CRYSTAL RIVER UNIT 3 NUCLEAR GENERATING PLANT
AMENDMENT TO FACILITY OPERATING LICENSE

Amendment No. 151
License No. DPR-72

ATTACHMENT TO LICENSE AMENDMENT NO. 151

Figure 3.7.15-1 (page 1 of 3)
Burnup versus Enrichment Curve for
Spent Fuel Storage Pool A

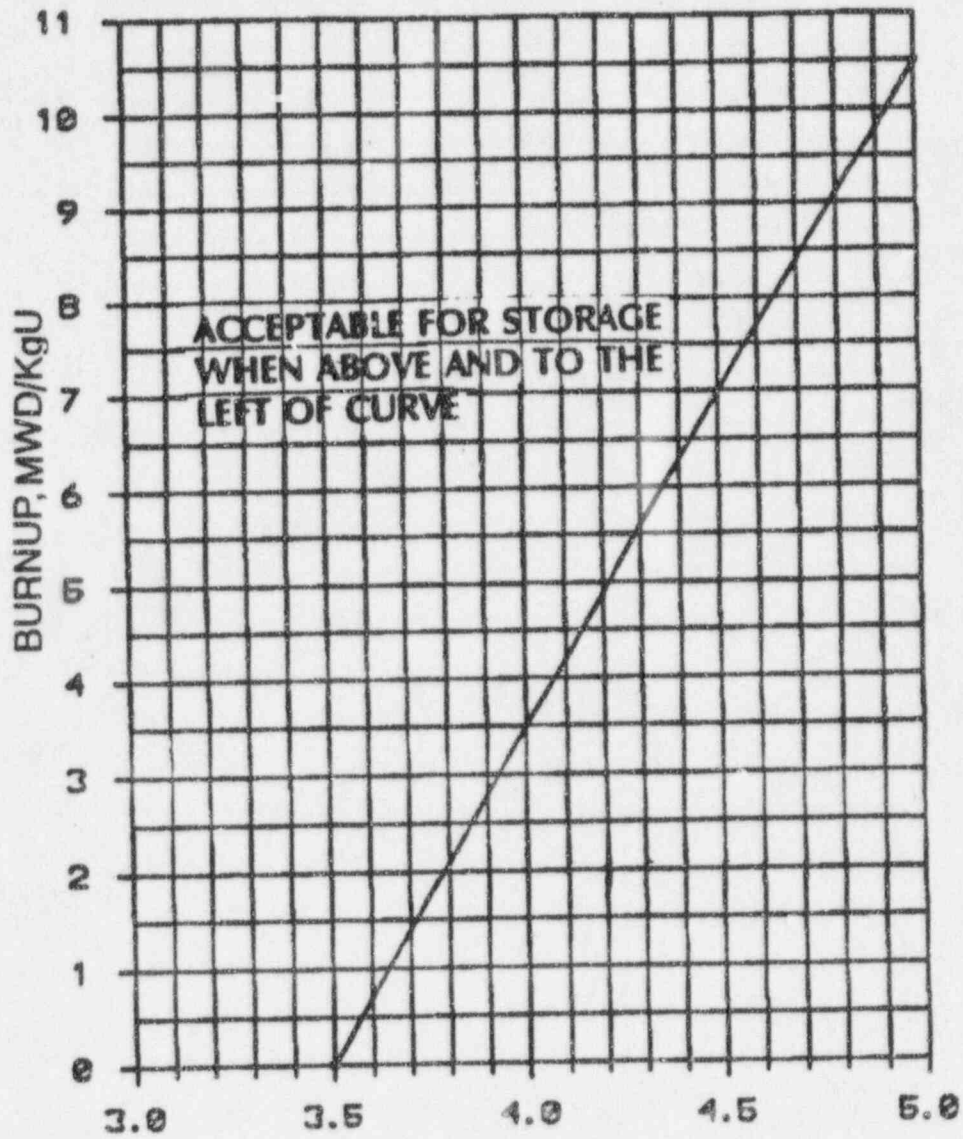
LCO 3.7.15 The combination of initial enrichment and burnup of each spent fuel assembly stored in Storage Pool A and Storage Pool B shall be within the acceptable region of Figure 3.7.15-1, Figure 3.7.15-2, Figure 3.7.15-3, or stored in accordance with the FSAR.

2. For spent fuel with initial enrichment less than or equal to 5.0 weight percent and greater than or equal to 3.5 weight percent, fuel burnup must be within the limits specified in Figure 3.7.15-1. (Figure 3.7.15-1 presents required fuel assembly burnup as a function of initial enrichment.)

Fuel enrichment limits are based on avoiding inadvertent criticality in the spent fuel pool. The CR-3 spent fuel storage system was initially designed to a maximum enrichment of 3.5 weight percent. Enrichments of up to 5.0 weight percent are permissible for storage in spent fuel pool A as long as the fuel burnup is sufficient to limit the worst case reactivity in the storage pool to less than 0.95. Fuel burnup reduces the reactivity of the fuel due to the accumulation of fission product poisons. Reference 1 documents that the required burnup varies linearly as a function of enrichment with 10500 megawatt days per metric ton uranium (Mwd/mtU) required for fuel with 5.0 weight percent enrichment and 0 burnup required for 3.5 weight percent enriched fuel.

Figure 3.7.15-2 (page 2 of 3)
Burnup versus Enrichment Curve for
Spent Fuel Storage Pool B, Region 1

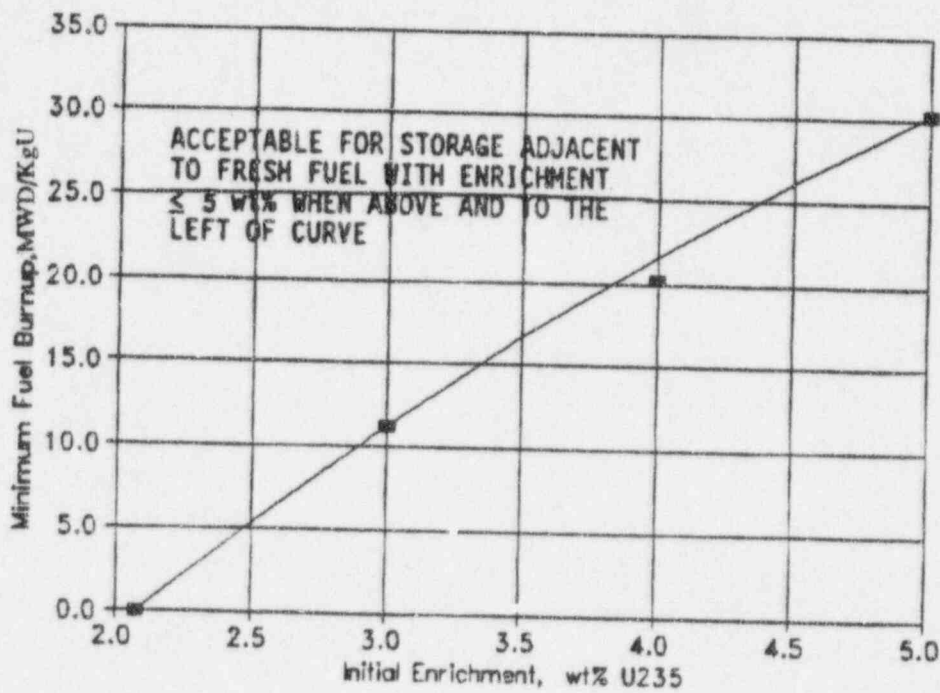
1. Initial fuel enrichment must be ≤ 5.0 weight percent U-235,
2. For Region 1, fuel with initial enrichment ≤ 5.0 weight percent and ≥ 2.08 weight percent fuel burnup must be within the limits specified in Figure 3.7.15-2 and arranged in a required checkerboard configuration with new fuel or burned fuel of ≤ 5.0 weight percent, and
3. For spent fuel with initial enrichment ≤ 5.0 weight percent and ≥ 1.63 weight percent in Region 2, fuel burnup must be within the limits specified in Figure 3.7.15-3. (Figure 3.7.15-3 presents required fuel assembly burnup as a function of initial enrichment.)
